**Notice of Allowability**

10/728,758

MATSUDA ET AL.

### **EXAMINER'S AMENDMENT**

Fig. 1

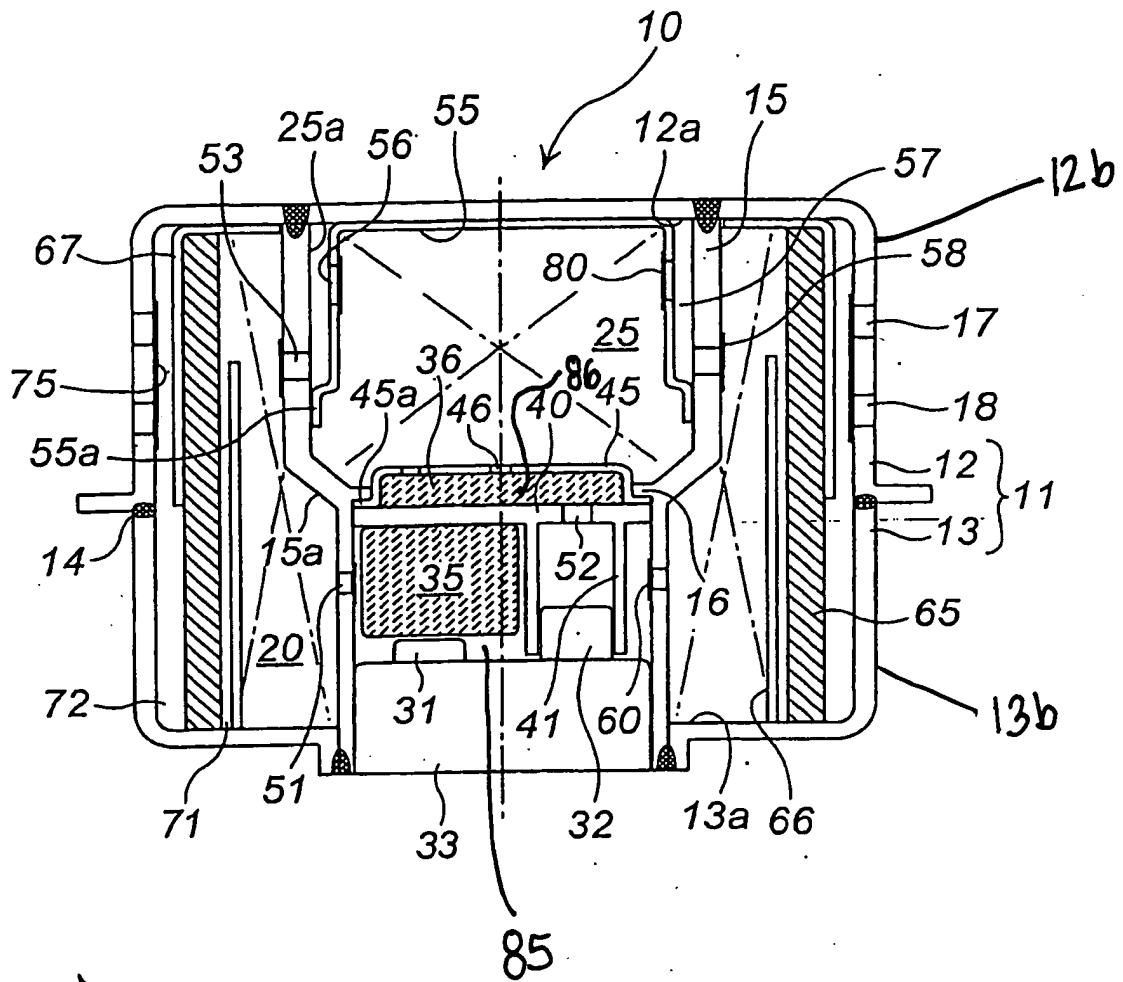
2. The following changes to the drawings have been approved by the examiner: reference characters 85 and 86 have been added to Figure 1 in reference to first and second ignition means chambers, and reference characters 12b and 13b have been added to Figure 1 according to the specification, see the attached marked up copy of Figure 1.

In order to avoid abandonment of the application, applicant must make these above drawing changes.
